## Watershed Management Commission

### Regular Meeting August 8, 2018 AGENDA

Fernbrook Athletic Fields  
Maple Grove, Project 2018-022  
July 12, 2018

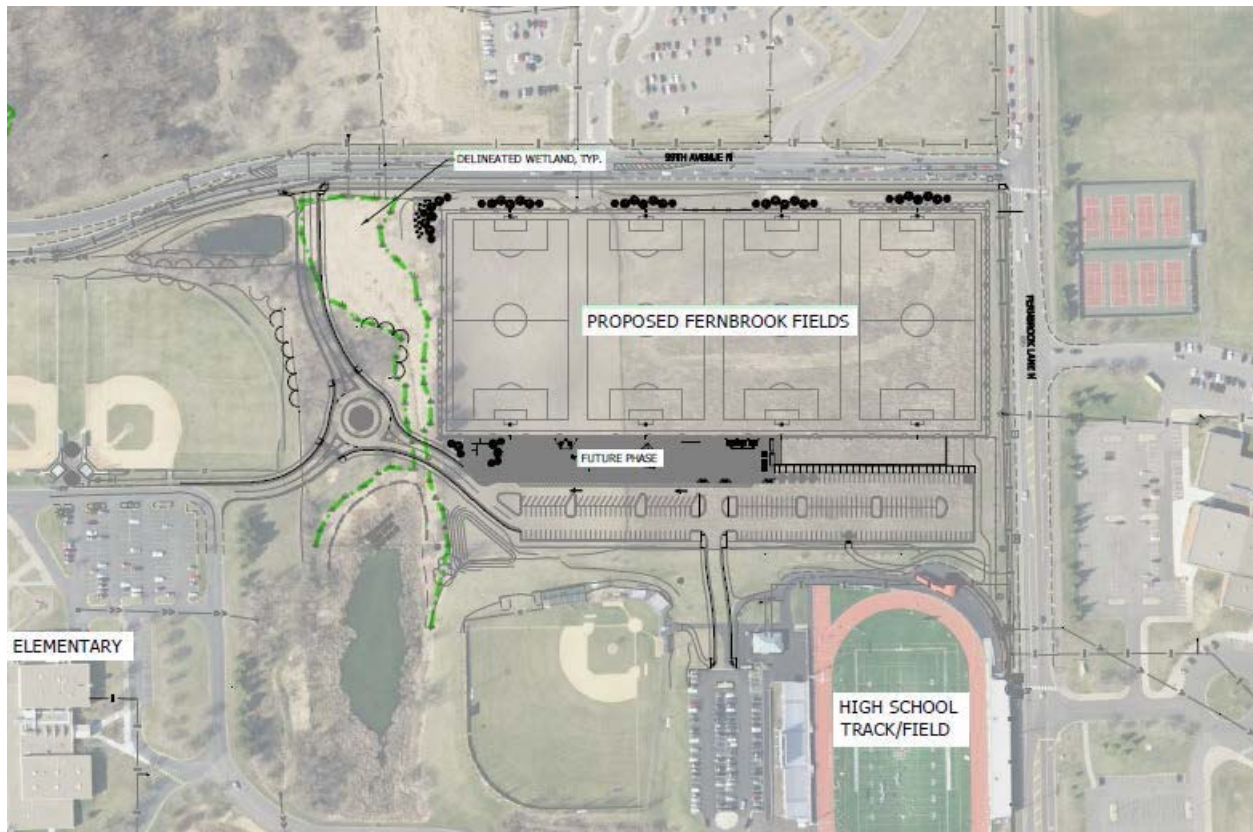
- a. Based on the storm sewer, it appears that there may be more tree trenches on the site that are not labeled as such on sheet C609. Applicant should clarify.

- a. Pretreatment of runoff prior to discharging to the filtration basin appears to be provided by sump manholes. Label the manholes and sump elevations on the project plans. We recommend some sort of device such as a SAFL baffle or other feature be installed in these manholes.

- b. The abstraction table provided in the memo assumes the filtration volume is provided between elevations 922.0 and 926.0 feet in elevation. However, the plan details show the overflow elevation from the basin to be at 925.0 feet in elevation. The volume above the outlet should not be included the abstracted volumes.

- c. The elevation of the overflow as shown on the project plans on sheet C303 do not match the details of the outlet as modeled in the HydroCAD report (923.0 versus 925.0.)

- a. Provide Existing Conditions pollutant loading numbers for TP and TSS, consistent with Commission Guidance that can be found here:  
[http://www.elmcreekwatershed.org/uploads/5/8/3/0/58303031/phosphorus\\_loading\\_coefficients.pdf](http://www.elmcreekwatershed.org/uploads/5/8/3/0/58303031/phosphorus_loading_coefficients.pdf)
- b. Show that removals are met using just the filtration basin as presently designed or modify the calculations to show the tree trench removals in addition if needed.
- c. Provide the actual MIDS model file in addition to the MIDS model output for review.
- d. The narrative memo provided by the applicant for the review, under item j indicates that additional information needed to be added to the memo.

- a. Wetland buffers meeting the commission requirements must be shown on the project plans.

- a. Submit the SWPPP plan for comment and review.

**No recommendation at this time.** Applicant should address the items under items 4a, 5a-d, 6a-d, 9a, and 10a, and resubmit for further review.
